INCH-POUND
MIL-C-39012C
AMENDMENT 8
3 August 1994
SUPERSEDING
AMENDMENT 7
30 October 1993

MILITARY SPECIFICATION

CONNECTORS, COAXIAL, RADIO FREQUENCY,
GENERAL SPECIFICATION FOR

This amendment forms a part of MIL-C-39012C, dated 11 August 1982, and is approved for use by all Departments and Agencies of the Department of Defense.

FIGURE 6. Safety wire hole pullout procedure."

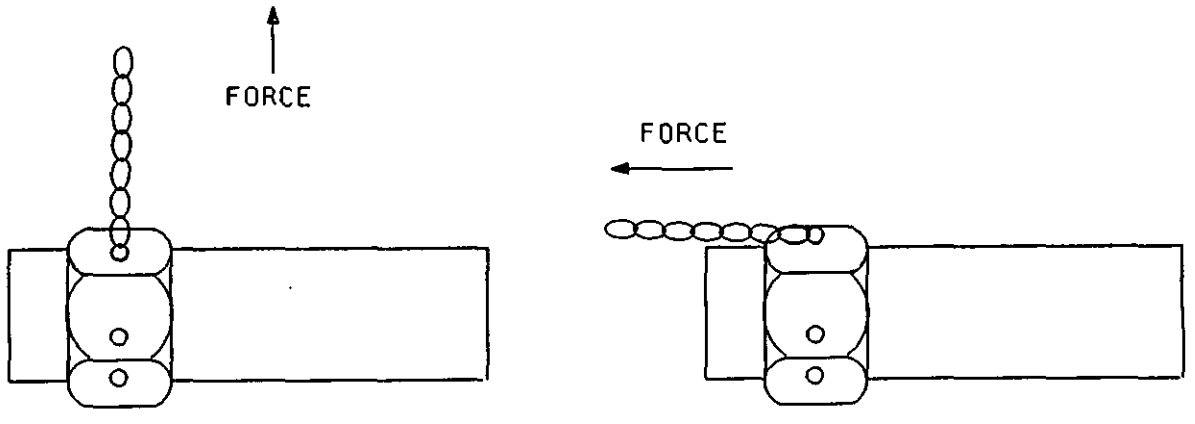
Add figure 6 as follows:

"4.6.25 Safety wire hole pullout (see 3.32). A single strand of safety wire shall be looped through the safety wire hole and secured to itself. Forces of 15 pounds (67 newtons) minimum shall be applied to the safety wire pulling away from the connector. One pull shall be parallel to the connector axis and one pull perpendicular to the connector axis (see figure 6). The safety wire shall be corrosion resistant steel .020 inch diameter (24 gauge) or .015 inch diameter, (27 gauge) in accordance with MS20995. This test is to be conducted under static conditions. All holes are to be tested individually."
